Re: Late Model Rule Amendment

Below is a rule amendment for the Late Model Division at the New London Waterford Speedbowl.

2016 New London-Waterford Speedbowl **ACT Late Model Rules**

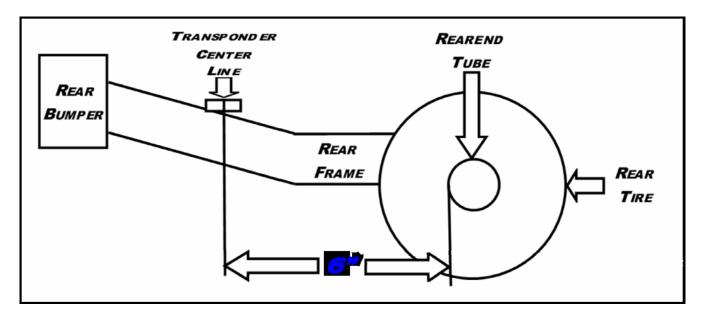
3.0.1) Scoring Transponder Location Transponder mounting brackets will be installed on the inside (or outside) of the right rear frame rail. The round post of the bracket must be on top and the square tab on the bottom flush with the lower edge of the frame rail. The bracket must be mounted with its center line exactly 12" 6" to the rear of the rear axle centerline and must be completely vertical to the ground. Transponders are required on the cars at all times. Any car not registering a transponder signal at the start of an event may be black-flagged to the pit area for repairs. Transponder scoring is used for all laps except the final (checkered flag) lap. Hand scoring is used to determine the finish, with any visual "ties" being broken by the transponder results.
